#### **BID ADDENDUM #7**

Nanuet Union Free School District 103 Church Street Nanuet, NY 10954

Nanuet Bond Projects Phase 4

Date: May 1st, 2024

SHEET NUMBER: BM-E103

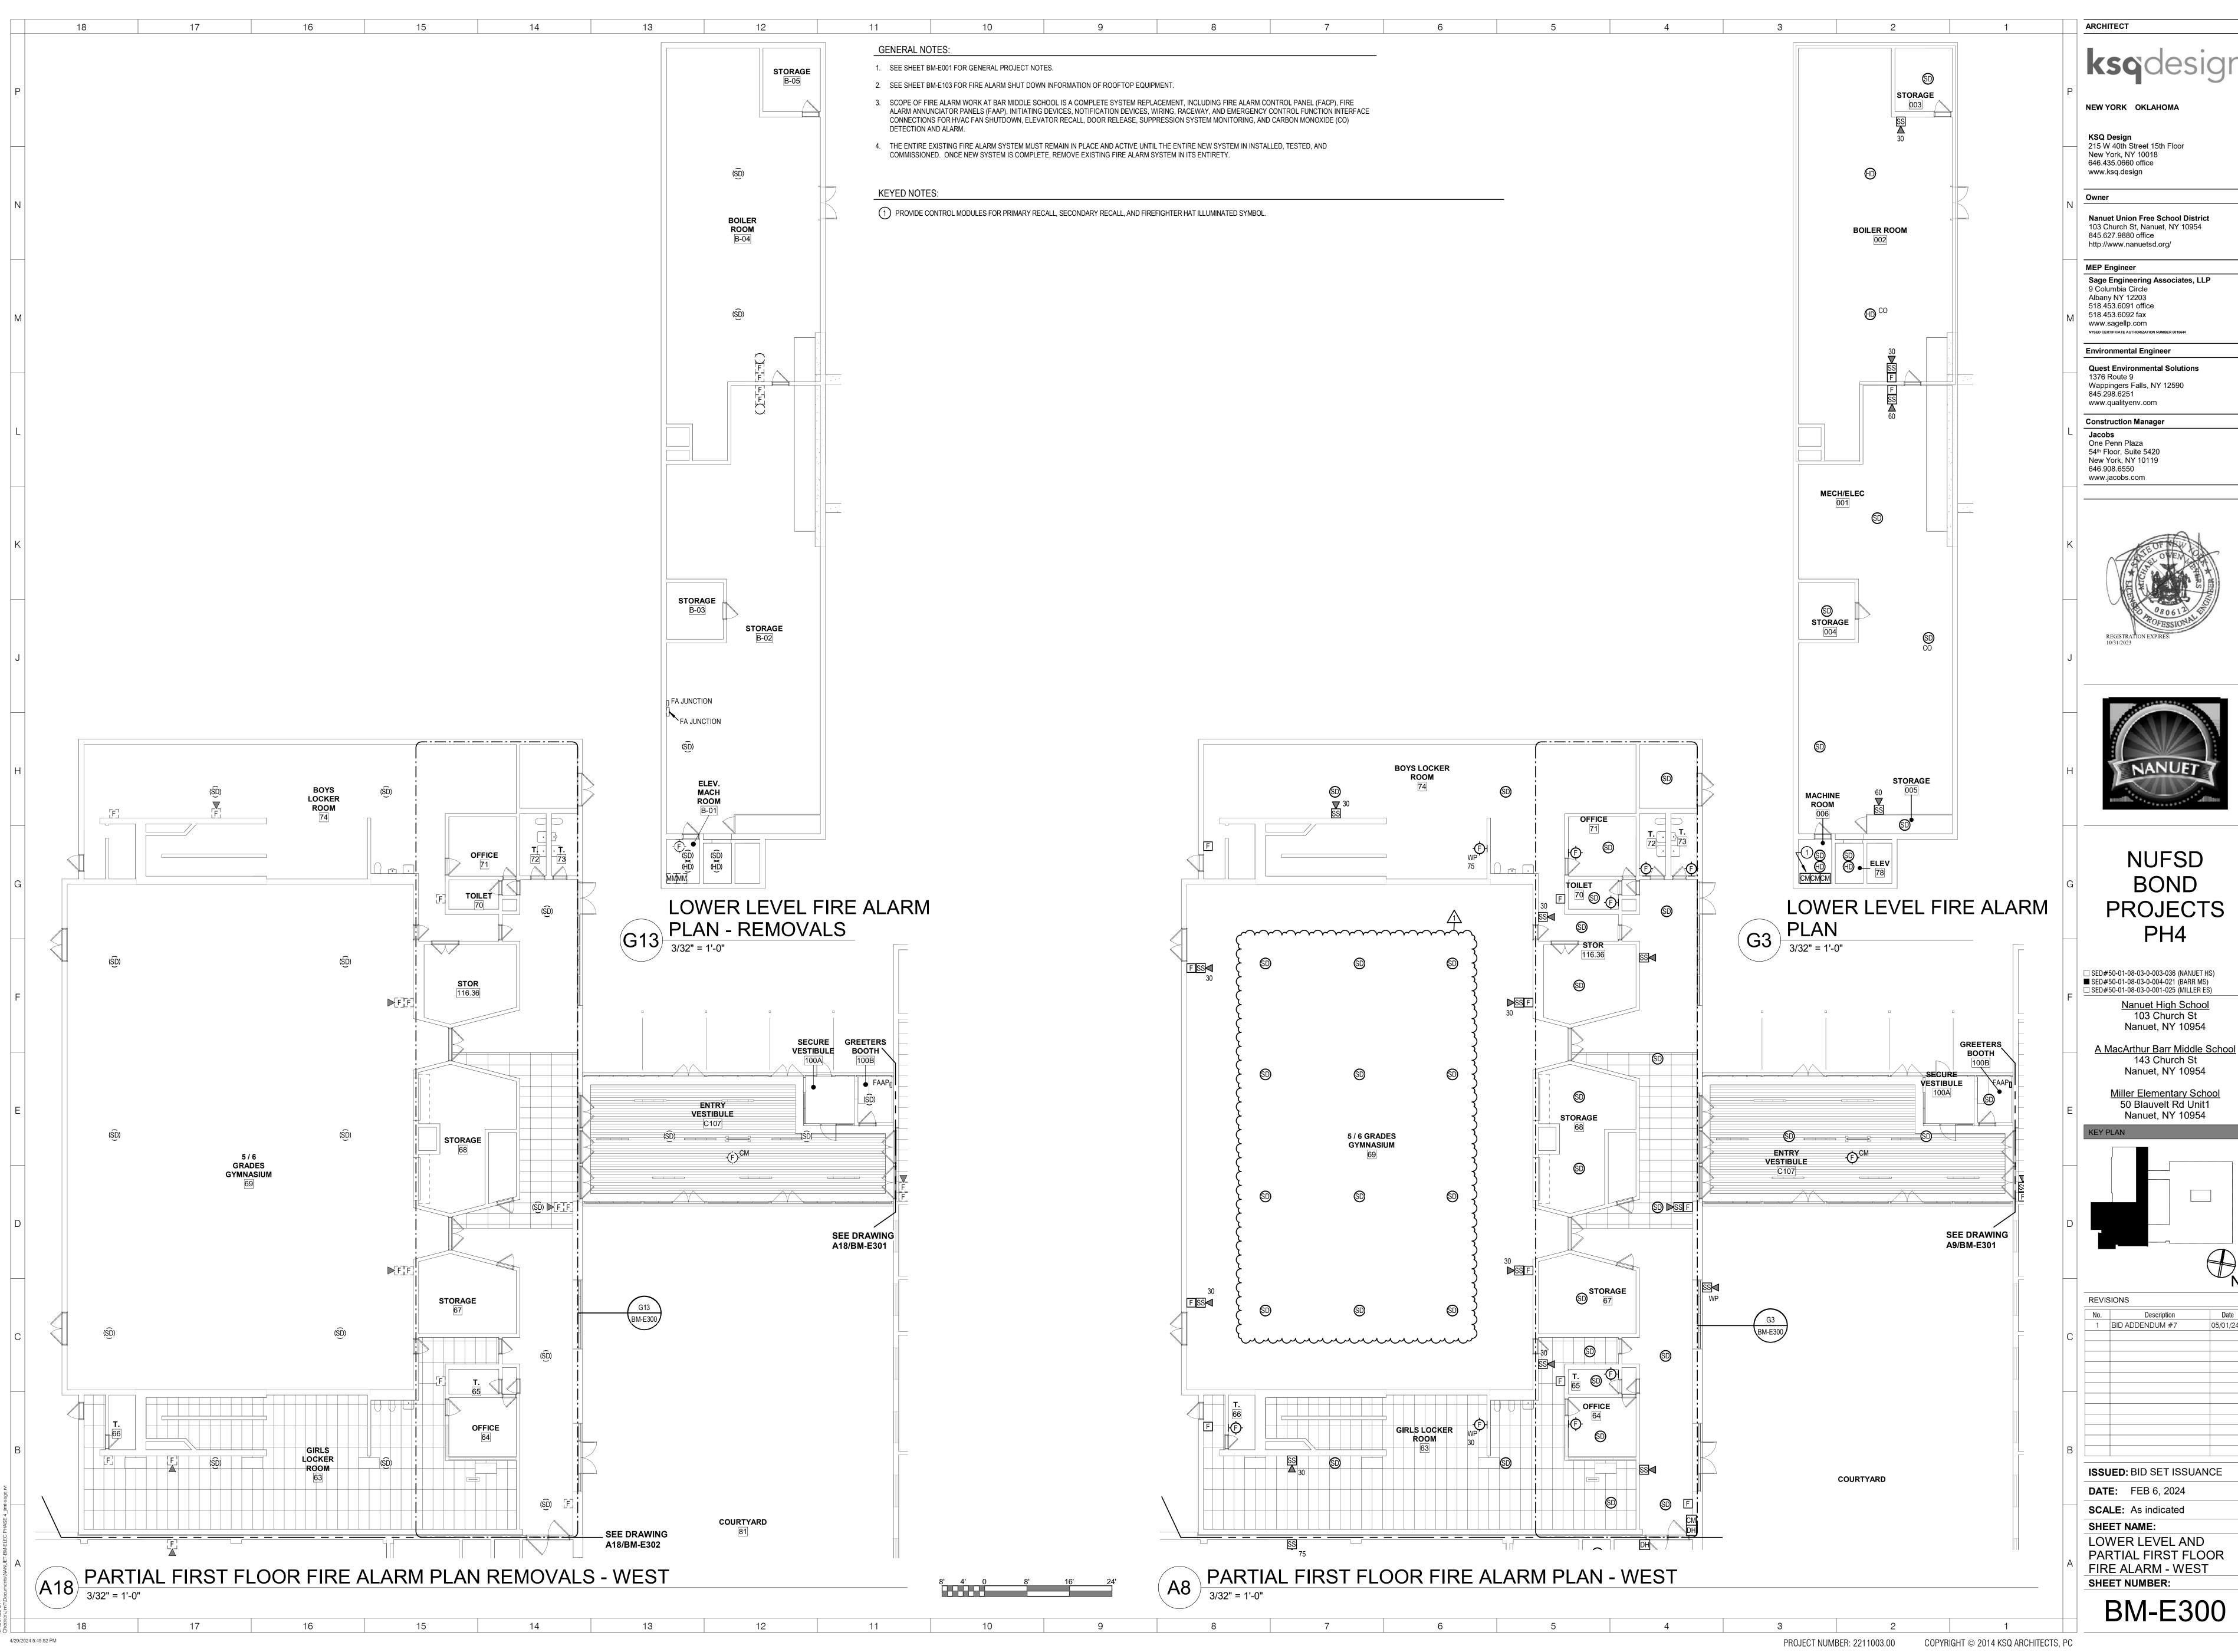
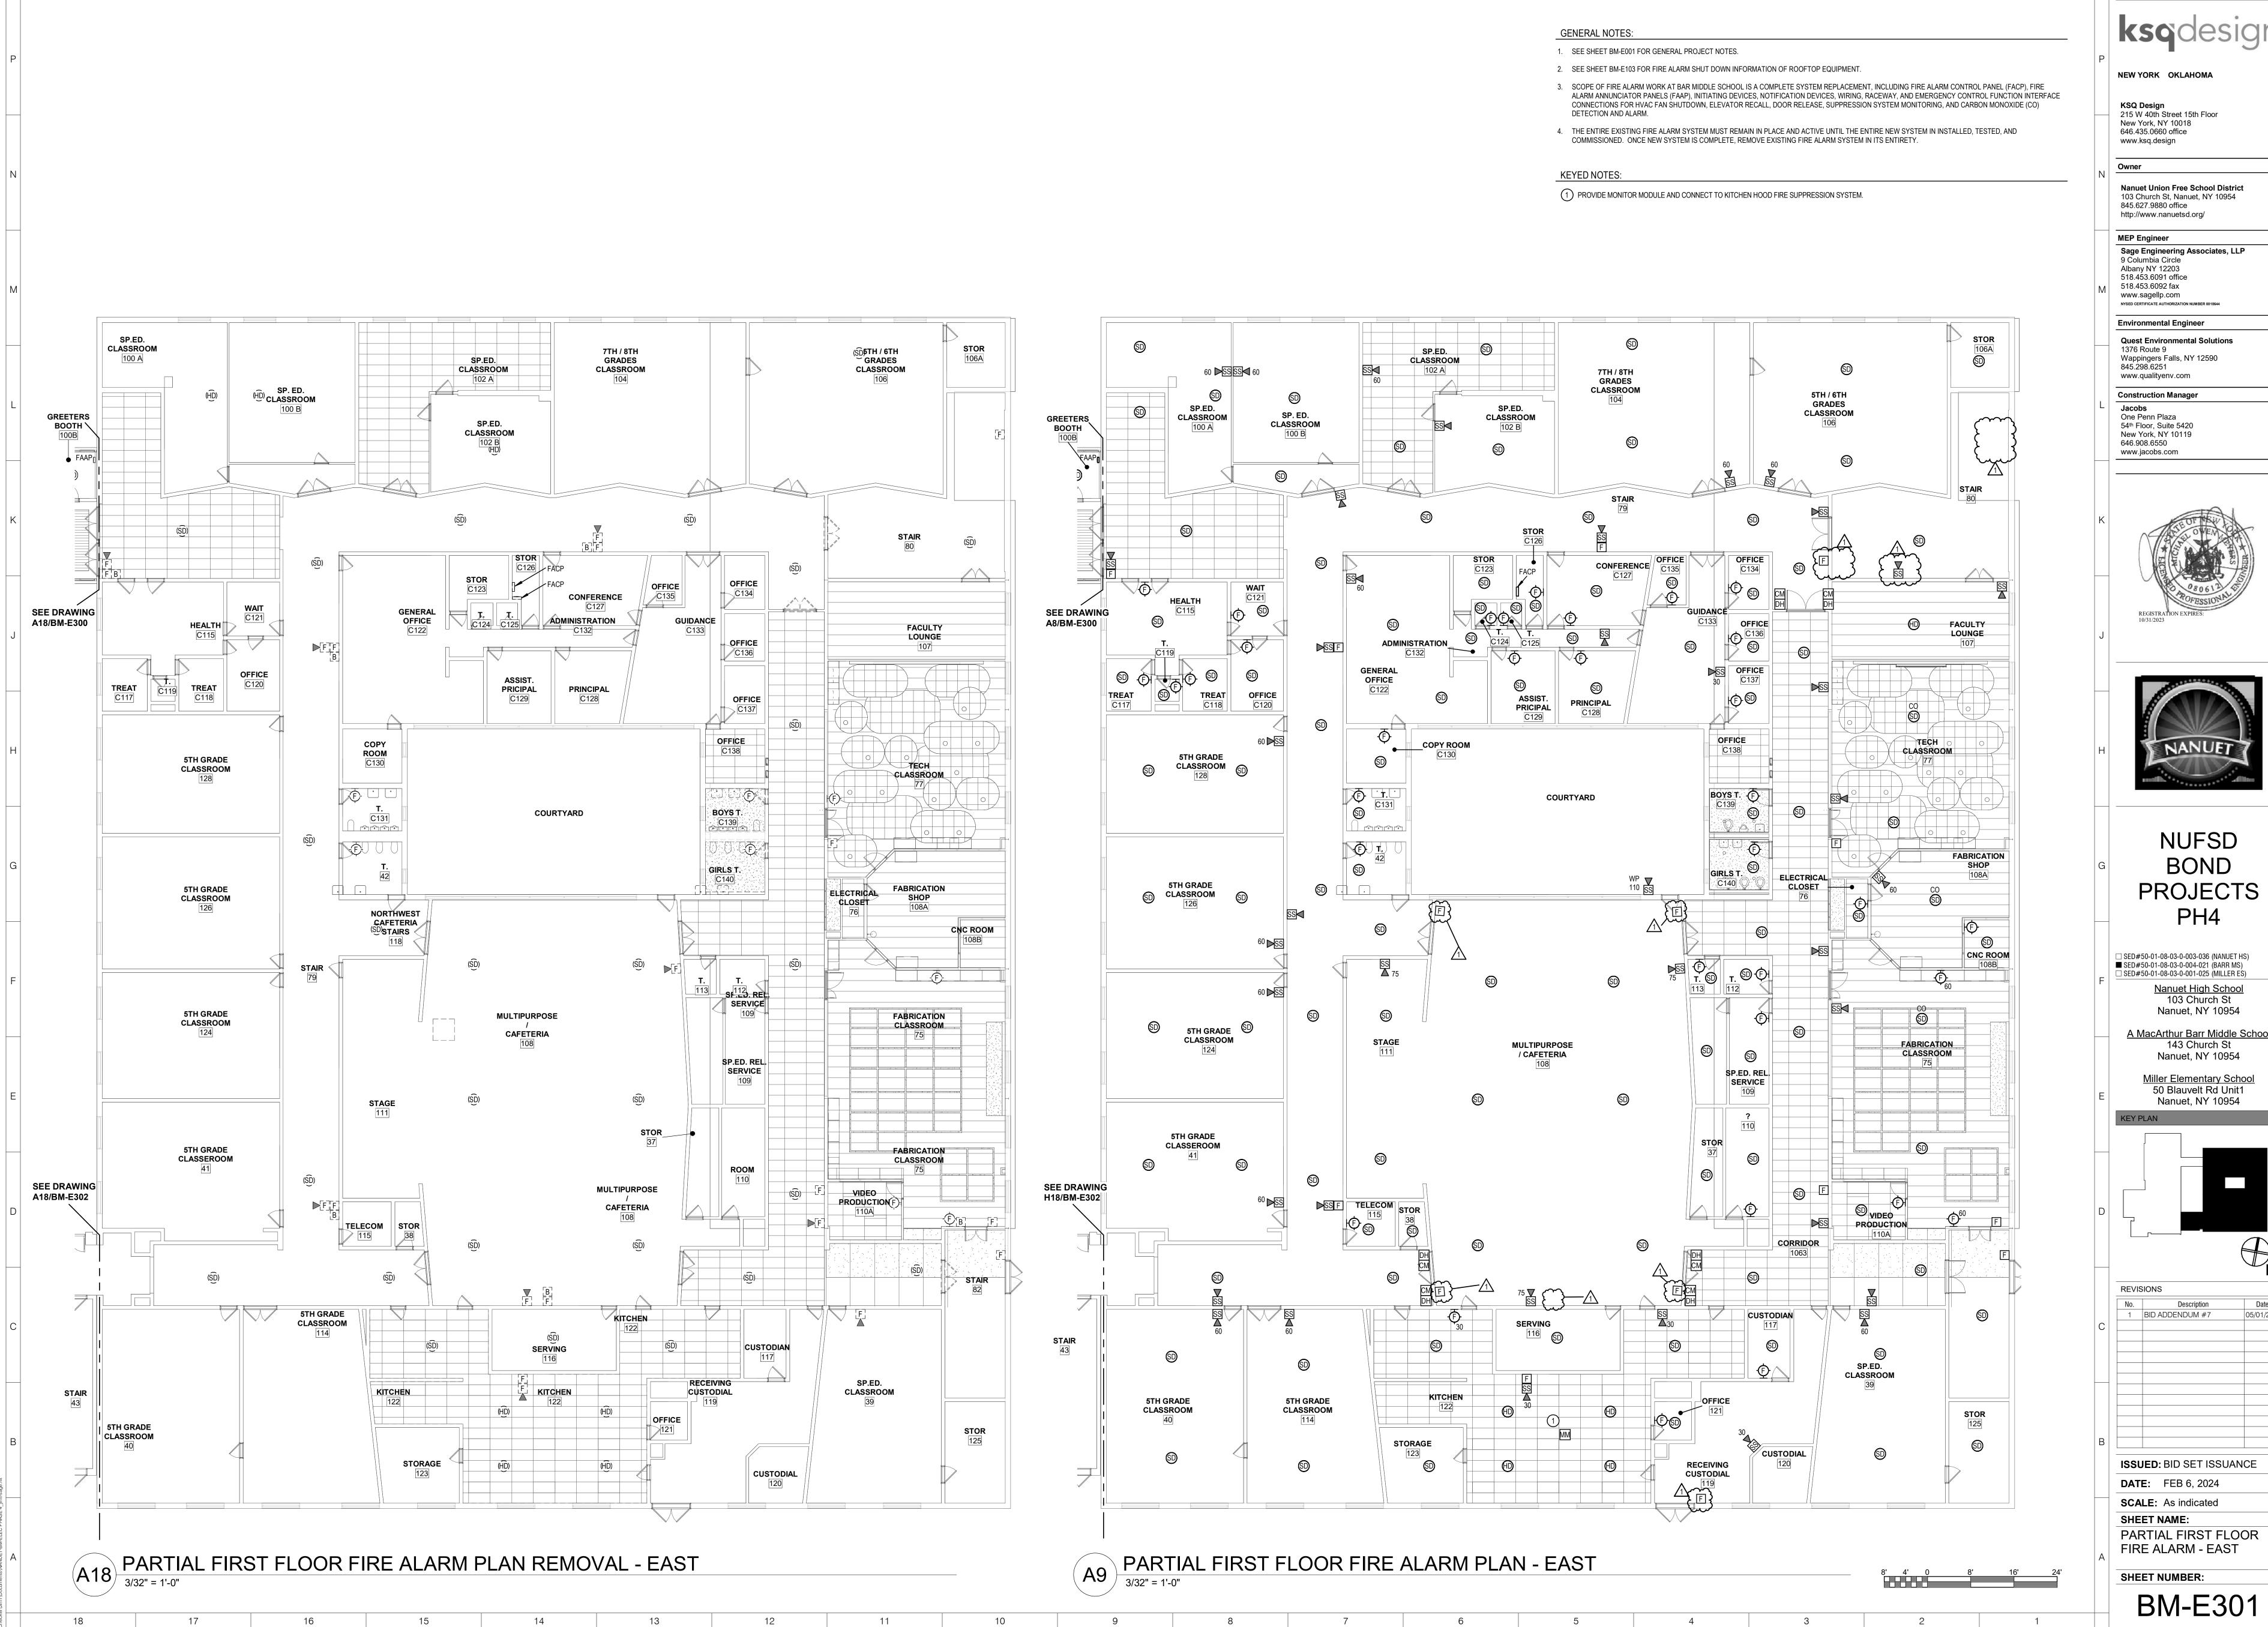
- 3. Sheet BM-E103: ELECTRICAL ROOF PLAN
  - A. Updated roof plan as noted
- 4. Sheet BM-E300: LOWER LEVEL AND PARTIAL FIRST FLOOR FIRE ALARM WEST
  - A. Updated Fire Alarm Plan at "5/6 Grades Gymnasium".
